Figure 20. Department of Energy integrated safety analysis methodology

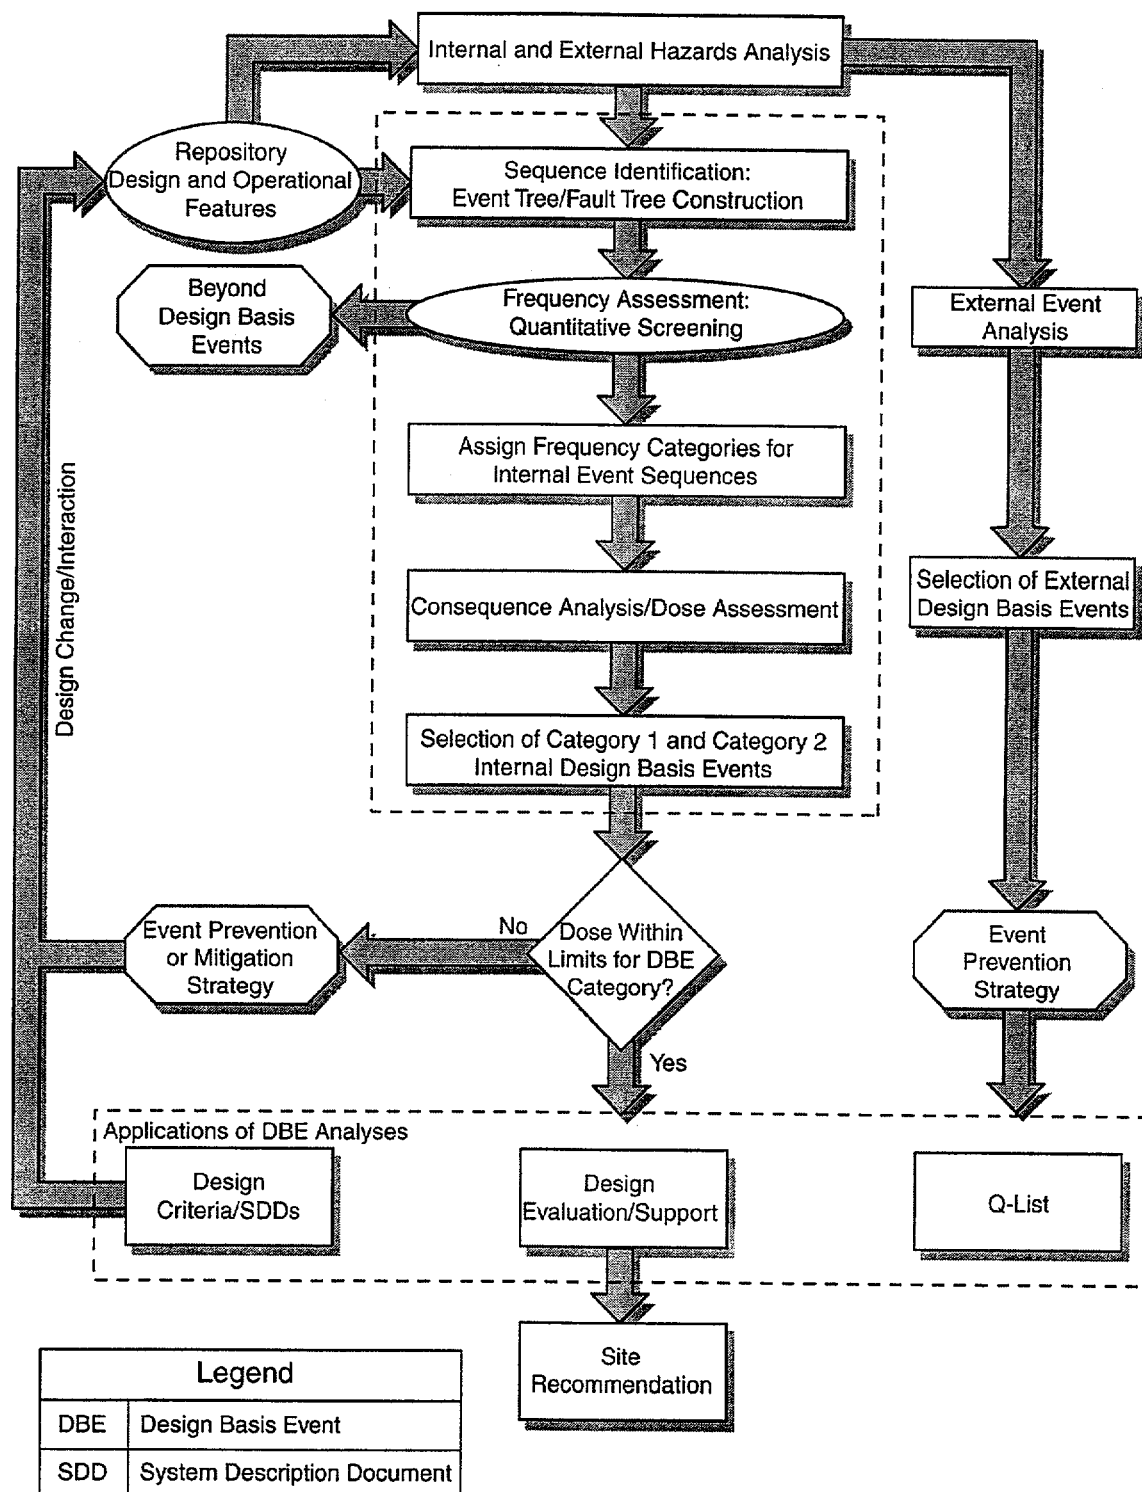
The DOE's methodology for ISA is schematically represented in Figure 20. The chart explains the process of implementation of ISA to meet the preclosure safety objectives through internal and external hazard analyses. The objective is to identify the DBE from internal (human-induced and equipment failures) and external (manmade and natural phenomena) events for consideration in the design of the GROA and identification and classification of the SSCs that are important to safety.
